Subject: FW: Cultural Resources Comments Relevant to FERC P-606 (Kilarc) Water Quality Certification

Re: Section 106 consultation; application for surrender of license for the
Kilarc-Cow Creek Project (FERC No. 606)

Re: Kilarc-Cow Creek Hydroelectric Project, FERC Project No. 606
Request that the Commission NOT designate PG&E as Non-federal representative

Photo was taken on 07-DEC-08, 9:48:34AM at N40 41 02.8. W121 49 02.6 at an elevation of 2679 ft.

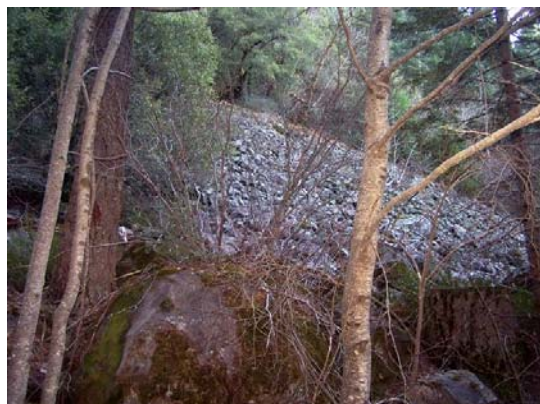
In the opinion of DH, the upstream section of the Kilarc headrace from the diversion down to the cornice a half mile downstream on the far side of the tunnel in particular may have been used as water for hydraulic face mining on the slope in the area on the downstream side of the tunnel. There are signs of hydraulic mining there.

We do not have good pictures of these faces as the focus of our pictures have been on the spawning gravel and juvenile fish habitats. However, see Photo 100_7542_exposure.JPG, below, for a poor view of one of the areas to which we are referring.
